**CITY OF CALLAWAY
POLE BARN PROJECT
BID NO.: CM2021-12**

ADDENDUM #1

Date Issued: September 8, 2021

Question # 2
Job #4

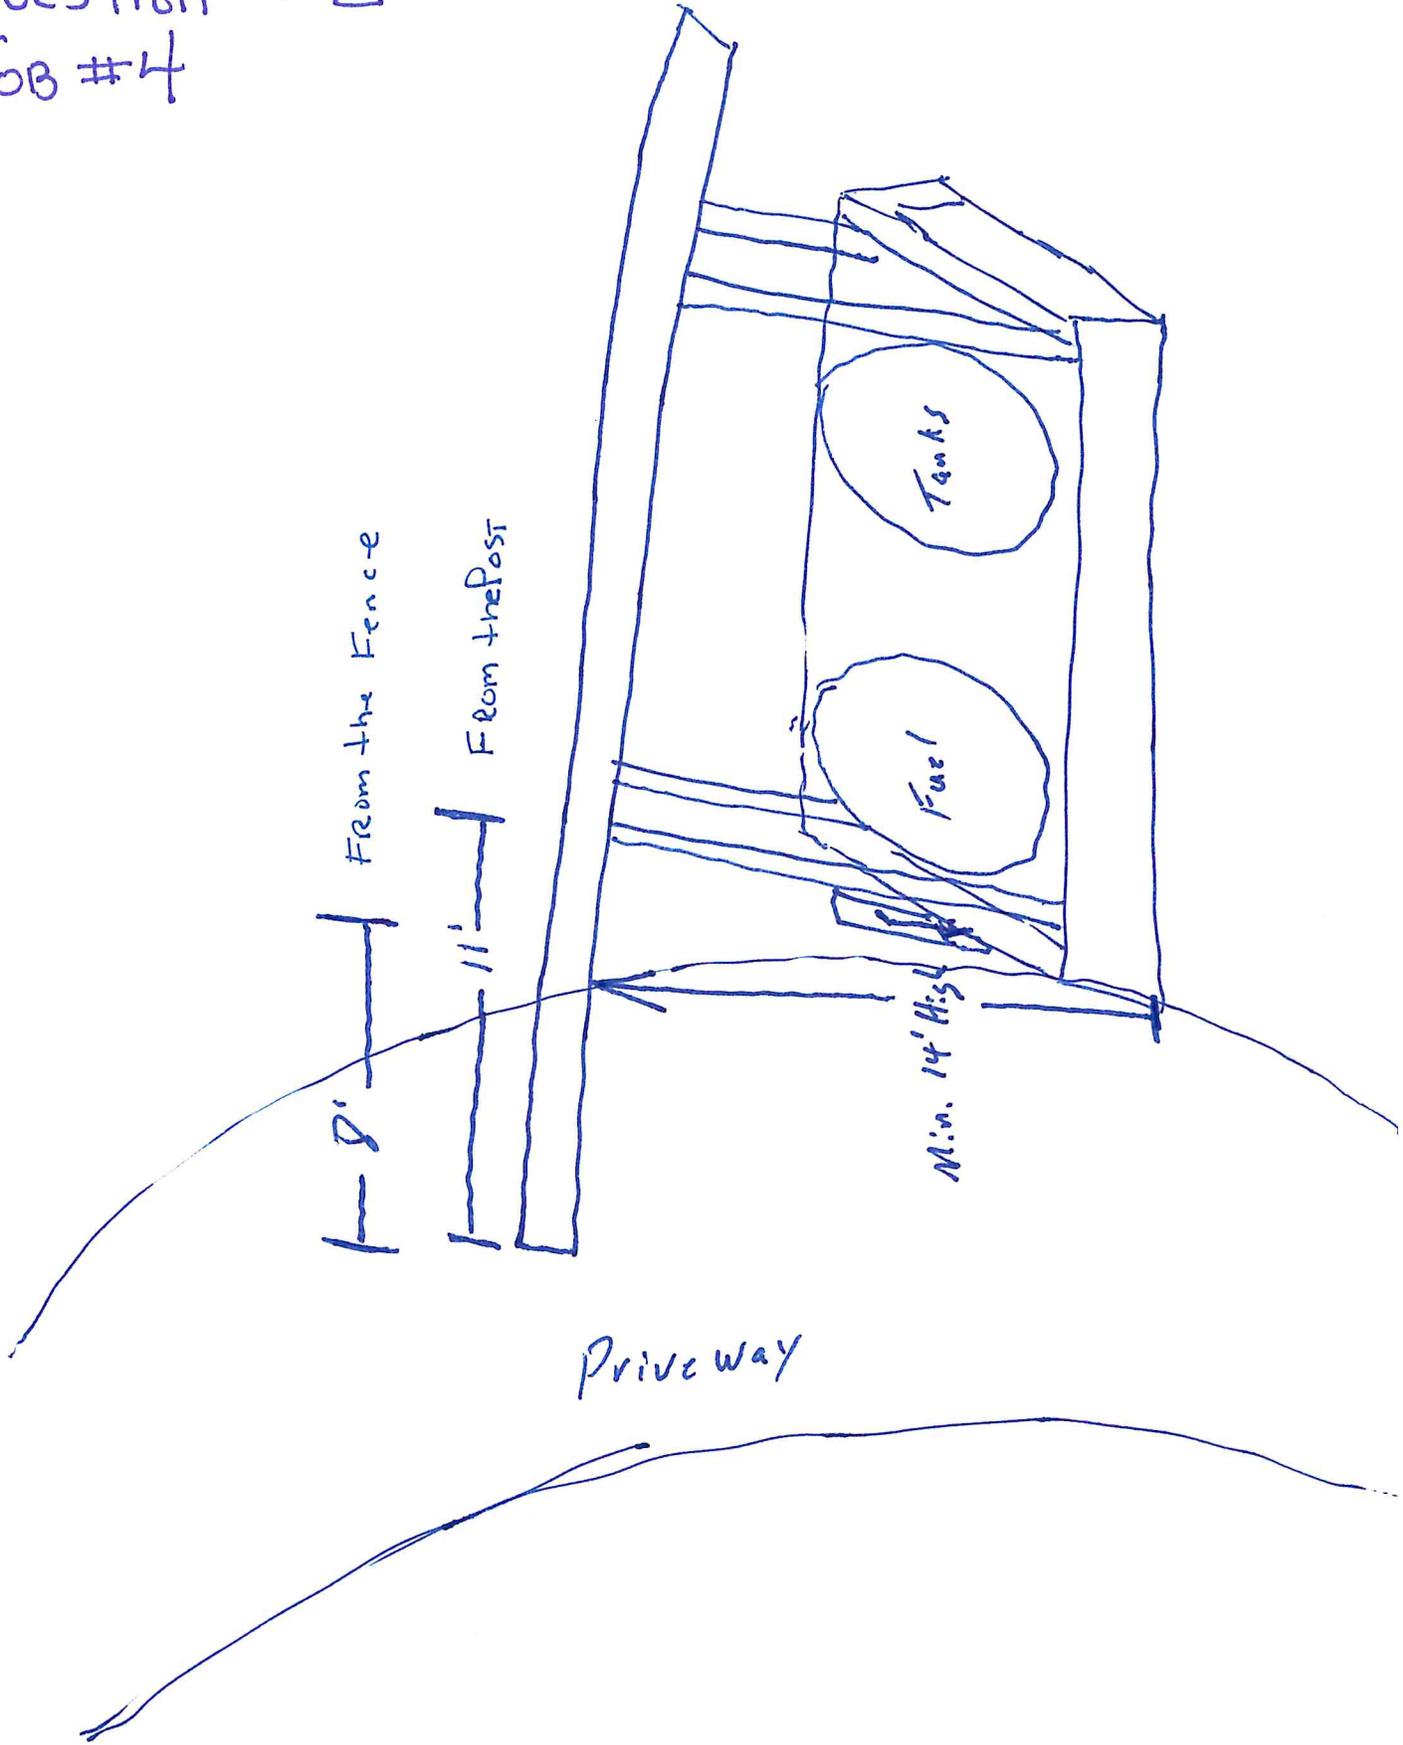
2. **For Job #4, are there any details on Cantilever measurement? We will need some form of outline to send to the engineer. See Attached drawing. The Cantilever will be placed 11' from the Post and 8' from the fence.**
